Re: **PRELIMINARY WATER QUALITY PLAN**  
Request for Ashford Woods  
Preliminary Plan #: 120200110  
SM File #: 285605  
Tract Size/Zone: 141.4 acres/R-90  
Total Concept Area: 101.4 acres  
Lots/Block: N/A  
Parcel(s): 787, 800  
Watershed: Ten Mile Creek SPA

**Department of Permitting Services**  
**Fire Department Access and Water Supply Comments**

**DATE:** 14-Oct-20  
**TO:** Brandon Frtiz  
Soltesz  
**FROM:** Marie LaBaw  
**RE:** Ashford Woods  
120200110

Re: Ashford Woods Performance Based Design Review  
Preliminary Plan #120200110

**ASHFORD WOODS**  
**PERFORMANCE BASE DESIGN**  
**BUILDING HEIGHT DETAIL**

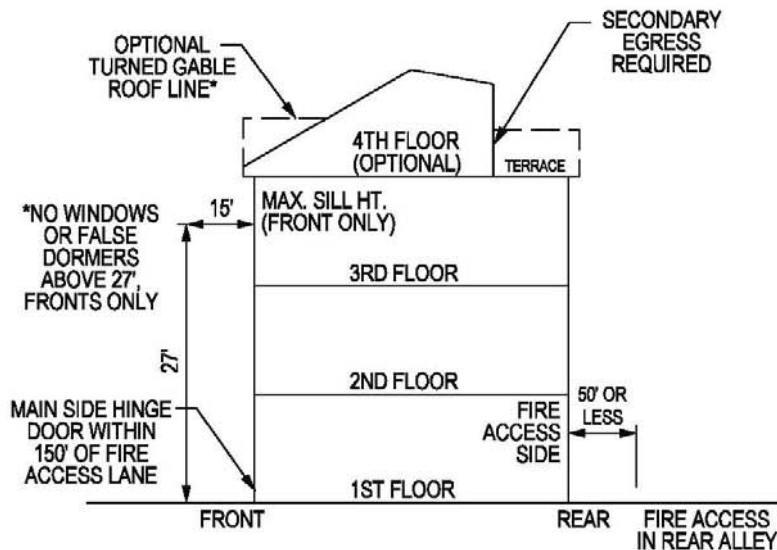
**\*\*\* See Statement of Performance Based Design for building height allowances: no false dormers permitted on fronts of height restricted units \*\*\***

As shown on the attached exhibit, many townhomes will have an optional partial fourth story available for purchase in their floorplans. For units where the front main side hinge door is more than 50 feet but less than 150 feet from a fire access lane the designation of 'FIRE HEIGHT RESTRICTED UNIT' will be shown on the plans. All 'FIRE HEIGHT RESTRICTED UNITS' in this development will have rear alleys that provide fire department access; these alleys will be within 50' of the rear wall of each unit. If the optional partial fourth story is constructed on a unit designated with a 'FIRE HEIGHT RESTRICTED UNIT' symbol, that unit will provide either an egress window, a 3' sliding door or a 3' side hinge door as a secondary egress on the rear wall of the optional fourth story. The rears of a FIRE HEIGHT RESTRICTED UNIT will be permitted to have window sills/dormers above 27 feet, while the fronts of these units will not be permitted sills/dormers, including false dormers above 27 feet.
